Certified Action of the City of Raleigh Planning Commission

Case File / Name: S-13-12 / Brookhaven Place Subdivision

Property owner: JTC, Inc.
Designer: Spaulding & Norris, P.A.

Staff Report

S-13-12 / Brookhaven Place Subdivision – Preliminary Subdivision Plan

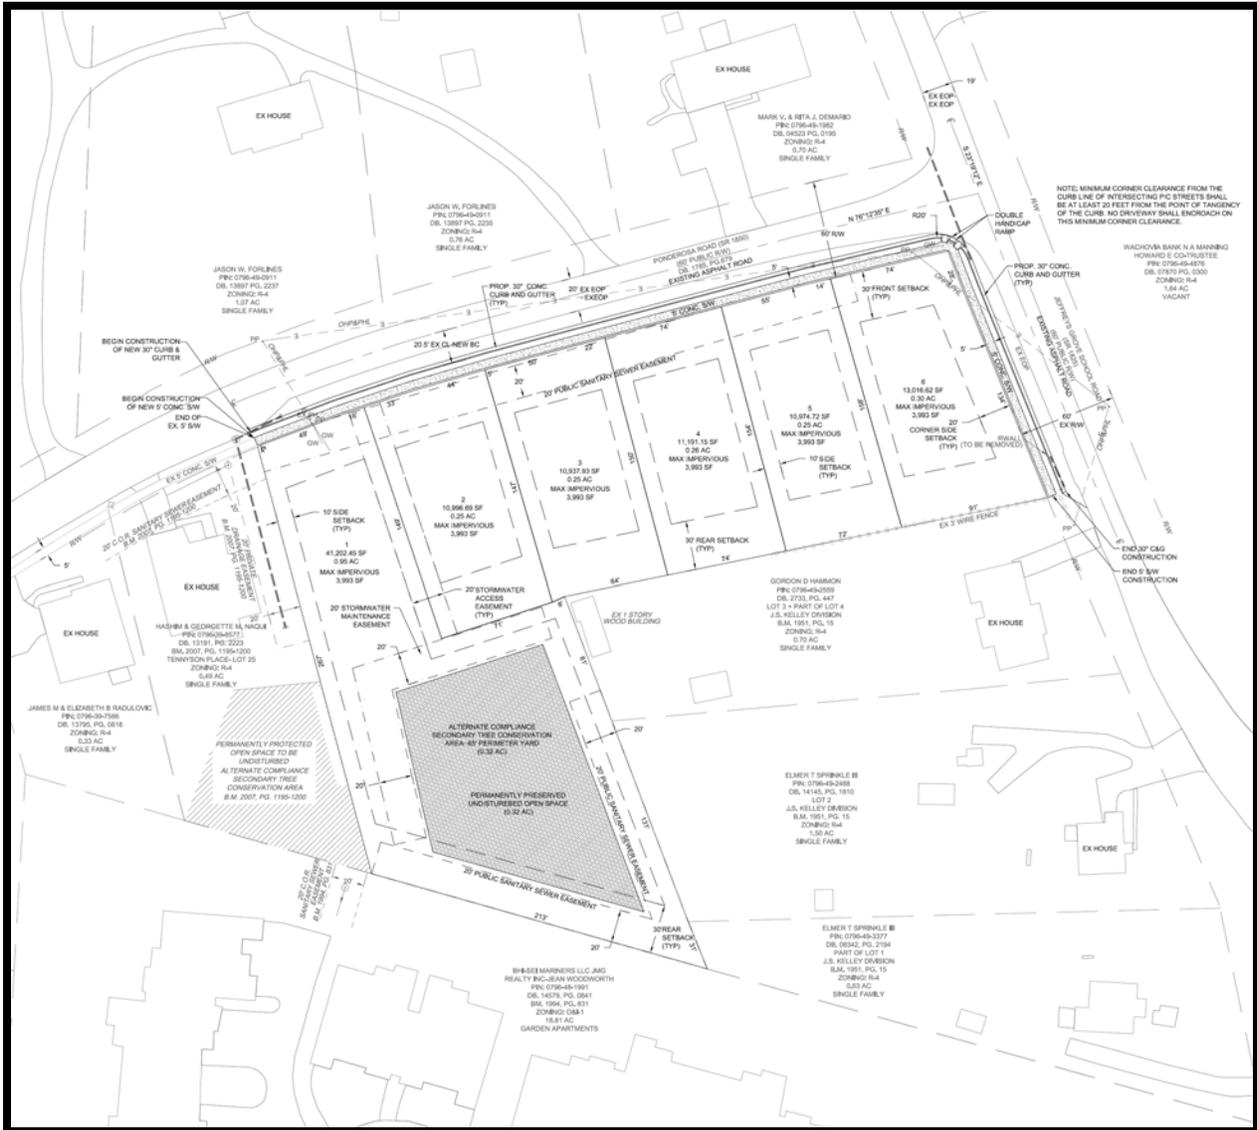
- (2) That prior to the issuance of a grading permit, the final tree conservation plan must be approved by the City's Forestry Specialist. The plan must show metes and bounds descriptions of all tree conservation areas, and tree protection fence around all tree conservation areas. Tree protection fence must be located in the field and inspected and a copy of the approved plan is to be placed on file in the Planning Department;

- (3) That as the developer has chosen to offset a portion of nitrogen export load limitation by paying monies to the North Carolina Ecosystem Enhancement Program (NCEEP) in accordance with Nitrogen reduction requirements of Section 10-9022, this payment shall be made to NCEEP and verification of the amount of payment shall be provided to the City of Raleigh Stormwater Engineer;

- (4) That a stormwater control plan with a stormwater operations and maintenance manual and budget shall be approved by the Stormwater Engineer in compliance with Part 10 Chapter 9, including the designation of buffer areas and open space areas for stormwater purposes prior to grading or the approval of construction drawings, whichever event comes first;

- (5) That a tree conservation map be recorded with metes and bound showing the designated Tree Conservation Areas and shall be in compliance with Code section 10-2082.14;
- (6) That infrastructure construction drawings be approved by the Public Works Department prior to issuance of any permits or recording of any plat for this development;
- (7) That a security (letter of credit or performance bond) in the amount of 1.5 times the cost of improvements will be required to be provided to the City for all public improvements prior to building permit issuance or map recordation, whichever first occurs;

- (8) That a recombination map be recorded prior to or in conjunction with the recording of lots, recombining the existing lot into a single tract;
- (9) That the construction drawings and plat for recording show the extension of the proposed sanitary sewer easement to the western property line and that on the north side the easement is contiguous to the right of way;

- (10) That all stormwater control measures and means of transporting stormwater runoff to and from any nitrogen and stormwater runoff control measures shall be shown on all plats for recording as private drainage easements and the plats shall contain the following note: "All private storm drainage easements & stormwater measures will be maintained by the homeowner association."

TREE CONSERVATION: The preliminary plan shows .32 acres or 13% of secondary Tree Conservation Areas on the site, all of which are located on proposed lot #1.

CIRCULATION: Proposed street improvements shall conform to normal City construction standards. The developer of this property will widen the existing streets to ½ of a 41' B/B section with curb, gutter and a 5' sidewalk.

STORMWATER MANAGEMENT: The Subdivision will comply with Part 10, Chapter 9 Stormwater Regulations. Stormwater runoff will be detained to pre-development rates utilizing underground pipes as a shared BMP device located on Lot 1. Water quality (nitrogen) will be addressed by limiting the maximum amount of impervious allowed on each lot to 3,993 sf, designating Permanently Preserved Undisturbed Open Space on Lot 1, and a buydown to NCEEP. No floodplains or buffers exist on the site.
